MINERALS PROGRAM INSPECTION REPORT

MINE NAME: Cresson Project	MINE/PROSPECTING ID#: M-1980-244	MINERAL: Gold	COUNTY: Teller
INSPECTION TYPE: Monitoring	INSPECTOR(S): Timothy Cazier, P.E.	INSP. DATE: April 19, 2022	INSP. TIME: 09:50
OPERATOR: Cripple Creek & Victor Gold Mining Company	OPERATOR REPRESENTATIVE: Katie Blake & Johnna Gonzalez	TYPE OF OPERATION: 112d-3 - Designated Mining Operation

Photo 1. South Cresson bench failure (looking NE)

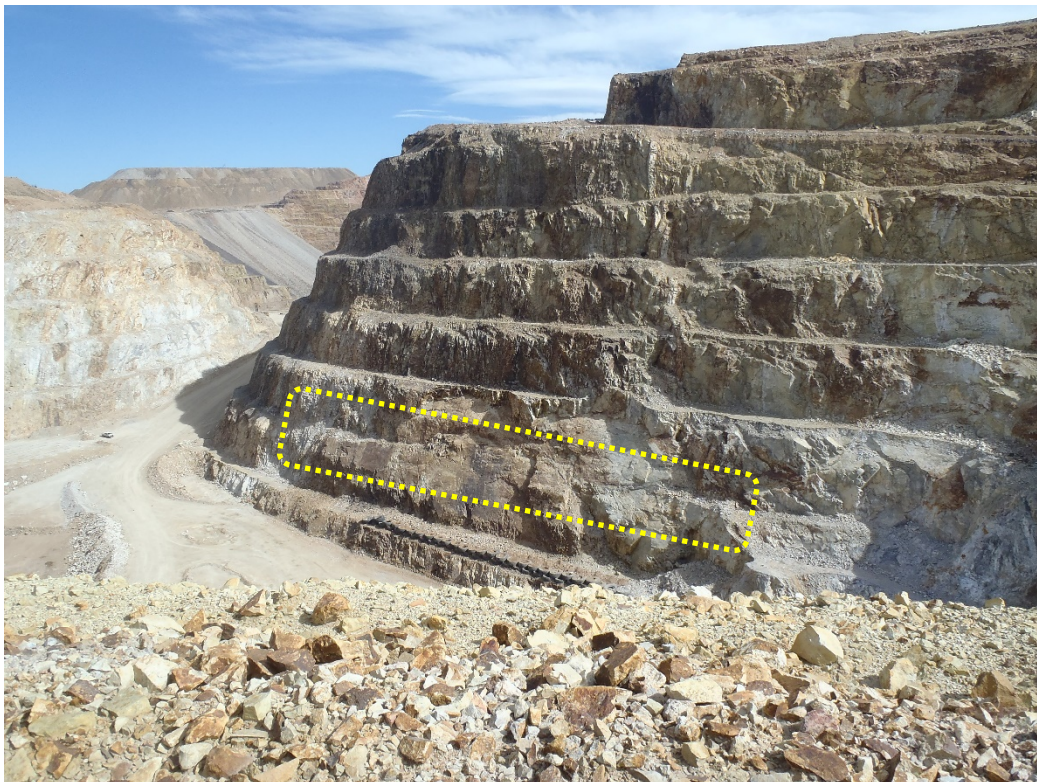
South Cresson Bench Failure: The Cresson bench failure (see **Photo 1**) was discussed in the DRMS' March 30, 2022 inspection report. A follow-up visit was performed during this inspection to observe the mitigation under much better visibility conditions. The DRMS had concerns related to the effectiveness of the haul truck tire build up mitigation on the bench below the failed bench to have sufficient capacity to capture sloughed rock above it during the post-reclamation period. Discussions with site representatives revealed this section of the highwall will be laid back during the phase 2 of the South Cresson pit mine plan. As such, the DRMS is no longer concerned with this issue.

Photo 2. Growth media stockpile #32 (circled), sloughing (arrow) (looking NW).

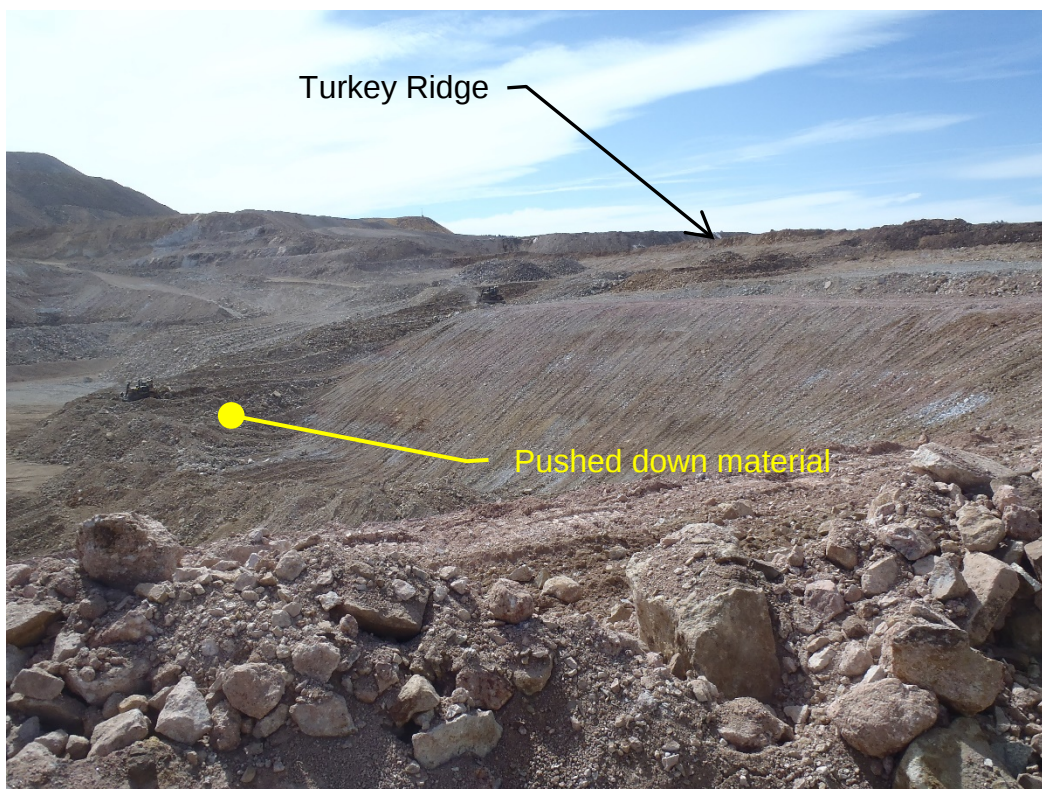
Growth Media Stockpile #32: The stability of Growth Media Stockpile #32 (GM-32) was discussed in the DRMS' March 30, 2022 inspection report. This was a follow-up visit to observe the stockpile under much better visibility conditions (see **Photo 2**). There was not a safe place to stop and inspect the stockpile up close due to its proximity to a major haul road. Photographs taken while driving past the stockpile were reviewed subsequent to the inspection. Review of these photos, suggests a small amount of growth media was lost either when the adjacent haul road was re-aligned, or shortly thereafter. Darker soil (typically indicating the presence of organic matter) can be seen in **Photo 2** on the east side of GM-32 below a scarp in the same area. The scarp is estimated to be on the order of two feet in thickness. The DRMS believes there is potential for the scarp to migrate to the north, resulting in the loss of additional growth media. However, given the thin nature of the scarp and that it's on the edge of the stockpile, additional growth media loss may not be significant. Nevertheless, [the GM-32 stockpile should be monitored to ensure significant growth media is not lost](#). Maria Bujenovic stated the annual report submitted to the DRMS reflected a reduction in the volume of growth media stockpiled in GM-32 (and the adjacent GM-33 across the haul road). The DRMS checked these records subsequent to the inspection and notes last year's annual report listed a combined GM-32/33 volume of 136,181 CY, which was reduced to 92,181 CY in this year's annual report. A reduction of 44,000 CY. Ms. Bujenovic indicated this material was placed as

Photo 5. VLF2 benches in question (looking NNE from VLF1 overlook).

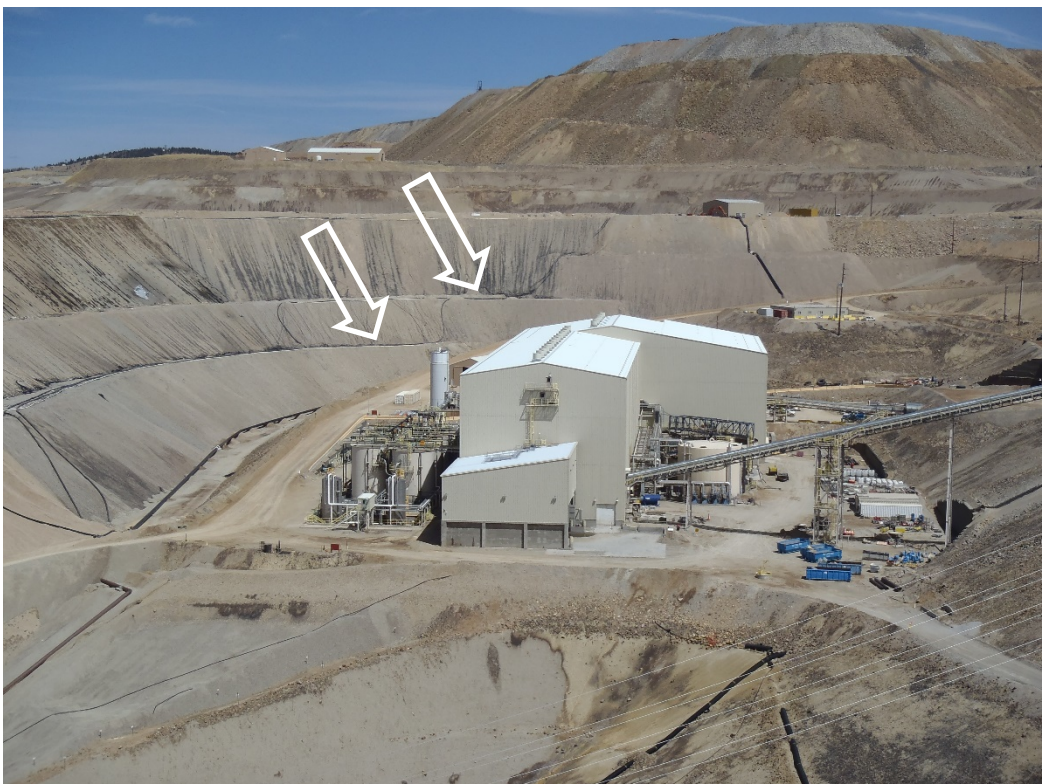
PROBLEM/POSSIBLE VIOLATION No. 2: Problem: The current mine plan related to ore stacking as approved with TR-103 appears not to have been followed above the HGM.

VLF 2 Ore Stacking: Photographs from the DRMS March 2022 aerial inspection indicated ore stacking on the southeast portion of VLF2, west of the High Grade Mill and north of the nearby projects office (see **Photo 5**) may not conform to the standards approved in TR-103. The ore stacking criteria for "Ore slopes above the Mill Platform were designed to be 2.0(H):1(V), a bench with a minimum width of 60' is required between the crest of the lower lift and the toe of the new lift." The TR further explains the 60-foot bench is required for the standard or typical 100-foot lift height. The area most concerning to the DRMS is that northwest of the projects building (see **Photo 6**). Site representatives concurred the bench observed in **Photo 6** was about 10 feet in width and the lift height was likely 50 feet. Pursuant to TR-103, the bench width for a 50-foot lift height would only need to be 30 feet, 20 feet wider than what was observed. **The inadequate bench width is cited as Problem 2 on page 1 of this report.** The prescribed bench width and lift height is intended to create an overall ore stack slope of 2H:1V in areas above the HGM. It is difficult to access a vantage point where additional bench widths and lift heights can be assessed. The DRMS requires as part of the corrective action, CC&V provide a contoured survey map/drawing of VLF2. The resulting map should have the following:

CORRECTIVE ACTIONS: The operator must provide sufficient topographic information (i.e., a contoured survey

map of the entire VLF2) to the DRMS by the corrective action due date, in order for the DRMS to fully evaluate the VLF2 ore stacking with respect to the TR-103 stacking plan addendum approved on May 22, 2020. The resulting map should have the following:

- 10-foot, labeled contours;
- Distinctive line types delineating the crest and toe of each bench/intermediate slope to facilitate bench width measurements; and
- Labeled bench elevations to easily determine lift heights.
